Project Reviews

Town of Erie

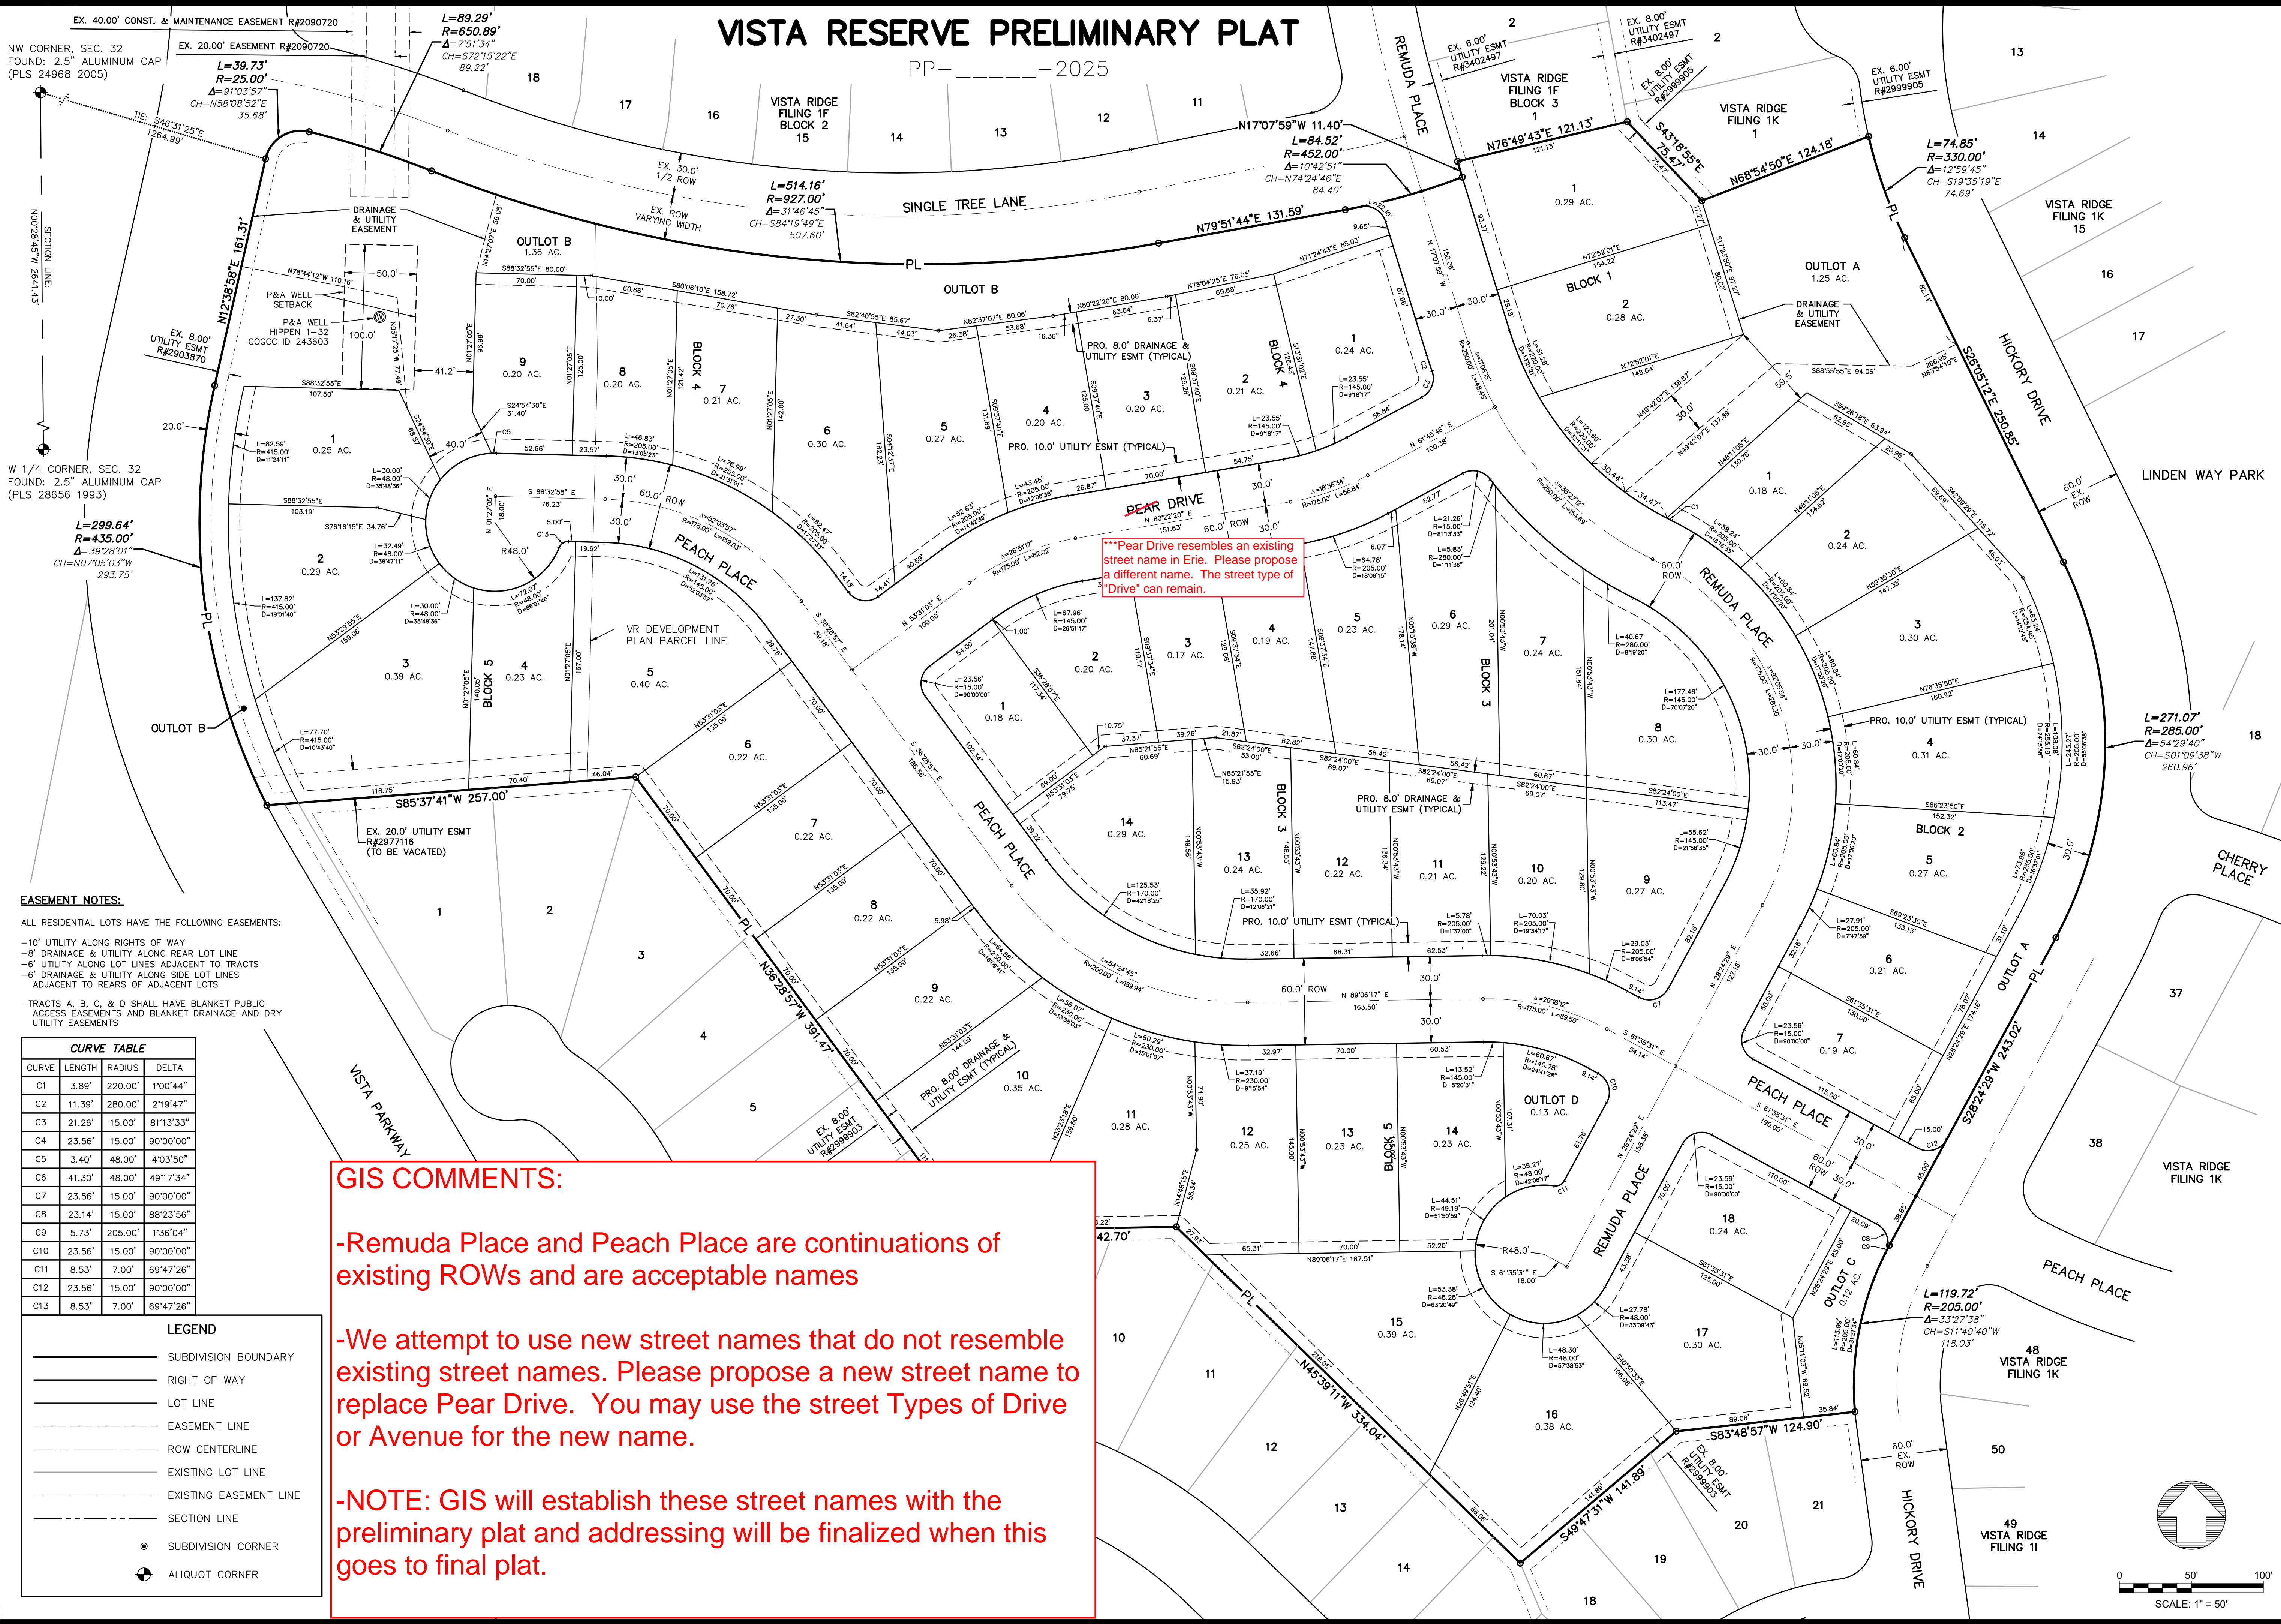
GIS COMMENTS:
